Airplane and Engine Certification Requirements in Supercooled Large Drop, Mixed Phase, and Ice Crystal Icing Conditions; Final Rule

[Docket No. FAA-2010-0636; Amendment Nos. 25-140 and 33-34]

ACTION: Final rule.

FIGURE 1 — Appendix O, Freezing Drizzle, Liquid Water Content

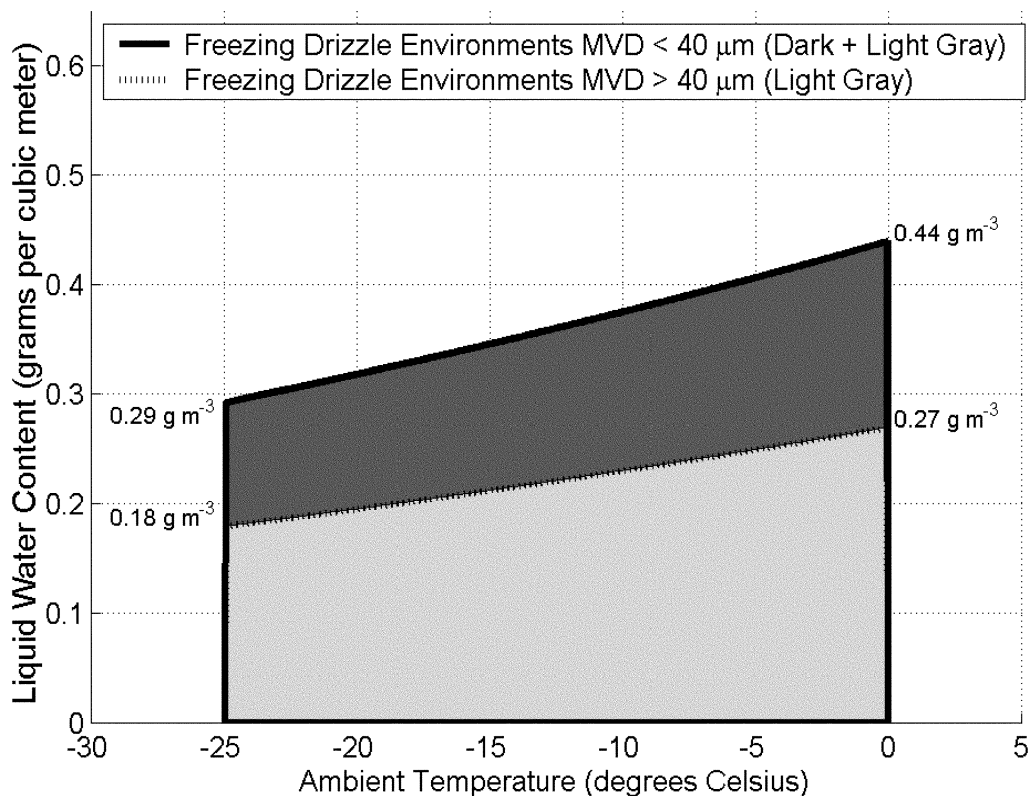
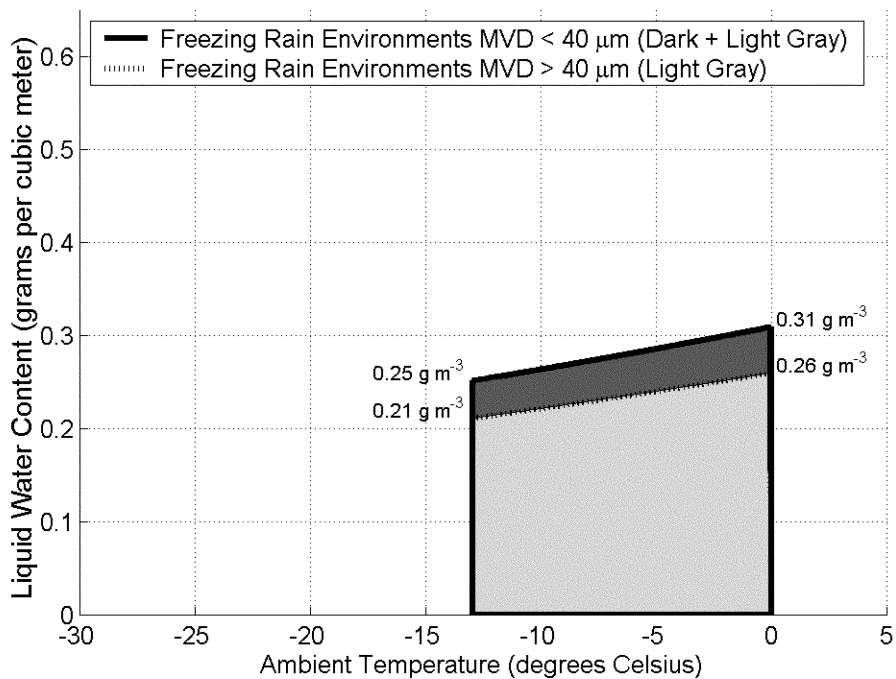
In response to other comments, figures 1 and 4 of appendix O have been revised in this final rule to reflect the LWC proposed by the IPHWG. As a result, freezing drizzle conditions with a median volume diameter (MVD) greater than 40 microns fall within the adverse region that would be identified using the University of Wyoming LWC/drop size technique. No changes to appendix O were made as a result of these comments.

Several commenters said that proposed figures 1, 4, and 7 in appendix O of the NPRM were different than what was proposed by the IPHWG, and that the FAA did not provide an explanation for those differences. The commenters also noted that the higher LWC contained in the figures proposed in the NPRM could have a significant impact on an applicant's design. GSIS specifically noted that the higher water content defined in appendix O will have

We agree. We reviewed the figures proposed in the NPRM and the data used by the IPHWG to generate the figures. We revised figures 1 and 4 to reflect the lower water content values proposed by the IPHWG, but the water content in appendix O is still higher than within appendix C at the same temperature. The higher water content may increase the power requirements for some electro-thermal deicing system designs, but not to the extent that may have been necessary with the water contents proposed in the NPRM. The environmental conditions defined in appendix O are valid conditions that will need to be considered for applicable future designs. Our review of the data used to generate the scaling factor curve in figure 7 indicates that the figure 7 proposed by the IPHWG in the task 2 working group report was incorrect;⁴ figure 7 in the NPRM was correct. Therefore, figure 7 in this final rule remains as proposed in the NPRM. Figures 1, 3, 4, and 6 of appendix O in this final rule have been revised to identify the corner data points for clarity.

FIGURE 6 — Appendix O, Freezing Rain, Temperature and Altitude

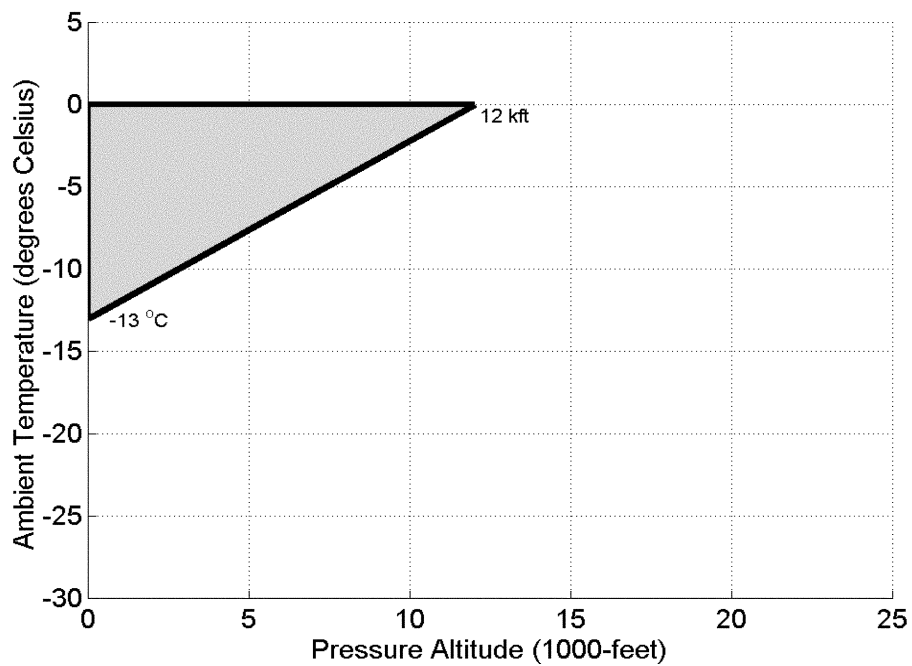
One commenter, a private citizen, noted that the NPRM did not identify the vertical extent for part 25, appendix O, figure 6. We disagree. The pressure altitude range and vertical extent for freezing rain were provided in appendix O, part I, paragraph (b) in the NPRM located under figure 3. We clarified appendix O, part I, by moving all of the general text describing the meteorological parameters, including vertical extent, ahead of the figures.

FIGURE 7 — Appendix O, Horizontal Extent, Freezing Drizzle and Freezing Rain

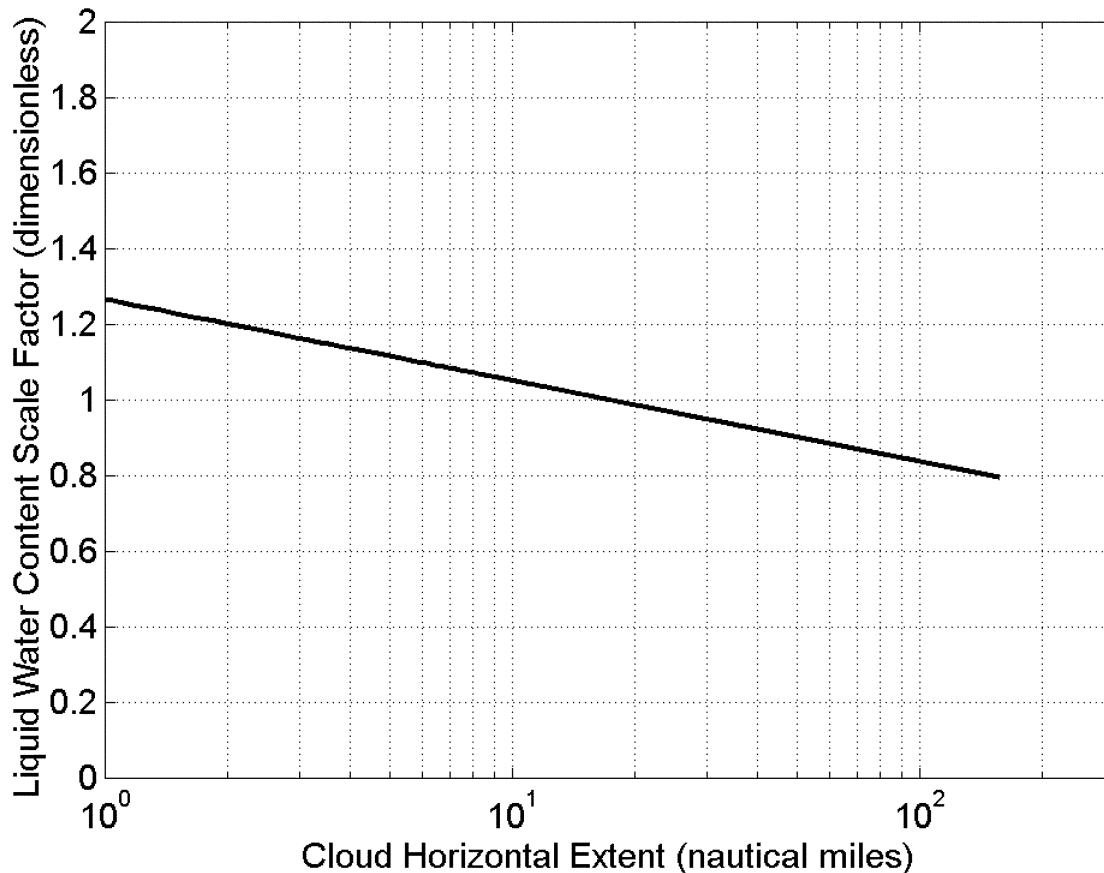
Boeing suggested a change to appendix O, part I, paragraph (c), to add an equation to determine the LWC for

We agree that adding such an equation could be beneficial. The equation proposed by Boeing, however, expressed horizontal distance in kilometers, which would be inconsistent with other figures in appendix O. Instead of the equation proposed by Boeing, we added to appendix O, part I, paragraph (c), a similar equation that uses units of nautical miles.

FIGURE D3 — Exposure Length Influence on TWC

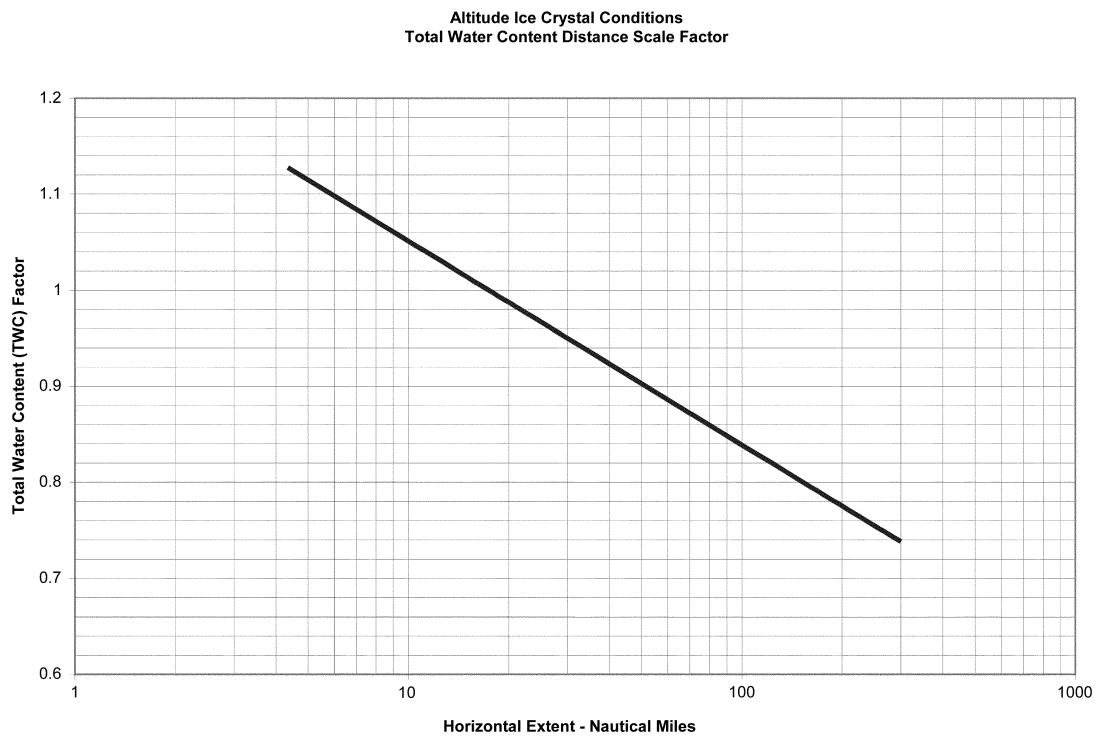
Snecma commented that the y-axis value in proposed part 33, appendix D, figure D3, was incorrect. The value should be 0.6 but the NPRM showed the value as zero.

33, appendix D, figure D3, to depict the correct axis values. The lowest x-axis value is now 1 and the lowest y-axis value is now 0.6.
